Access Compliance Report

Public Rights-of-Way (Curb Ramps)

Intersection ID: 48245	Main Street: LANIER_ISLANDS_CR	Cross Street: LAKE_ERIE_LN	Location: NW
ADA ID: 0E73E47DD8E2	Ramp Type: BlendTrans1	Initial Pass/Fail: Fail	Overall Compliance: No
Severity Score: 8.75			
Codes/Mitigation Info/Possible Solution		Field Measurements/Component Compliance

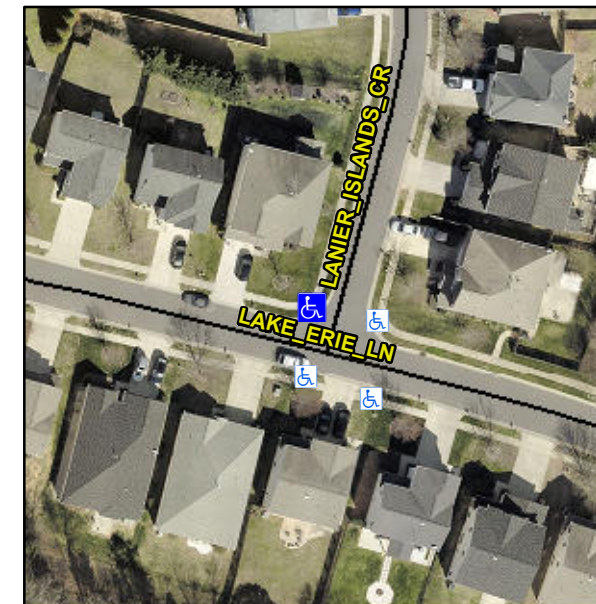
R304.5.1

Compliance	Description	Data	Compliance	Description	Data
N/A	Ramp Length (in)	47.0	Yes	BlendTrans Slope (%)	1.7
No	Ramp Width (in)	46.5	Yes	BlendTrans XSlope (%)	0.3
N/A	Flare Type LT	N/A	N/A	Flare Type RT	N/A
N/A	Flare Slope LT (%)	N/A	N/A	Flare Slope RT (%)	N/A
N/A	Flare Traversable LT?	N/A	N/A	Flare Traversable RT?	N/A
N/A	Landing Length (in)	N/A	N/A	DWS Provided?	N/A
N/A	Landing Width (in)	N/A	N/A	DWS Contrast?	N/A
N/A	Landing Slope (%)	N/A	N/A	DWS Length (in)	N/A
N/A	Landing X Slope (%)	N/A	N/A	DWS Full Width?	N/A
N/A	Landing Curb? (Y/N)	N/A	N/A	DWS Offset (in)	N/A
N/A	Shared Landing?	N/A			
N/A	Gutter Ponding?	N/A	N/A	Gutter Slope (%)	N/A
N/A	Gutter Lip Ht (in)	N/A	N/A	Gutter X Slope (%)	N/A
N/A	Painted X Walk1?	No	N/A	Painted X Walk2?	No
	X Walk 1 Direction	To S		X Walk 2 Direction	To E
	X Walk 1 Width (in)	N/A		X Walk 2 Width (in)	N/A
	X Walk 1 Slope (%)	2.5		X Walk 2 Slope (%)	1.3
	X Walk 1 X Slope (%)	2.6		X Walk 2 X Slope (%)	4.2

Remove & Replace Curb Ramp With Two New Directional Ramps or Equivalent.
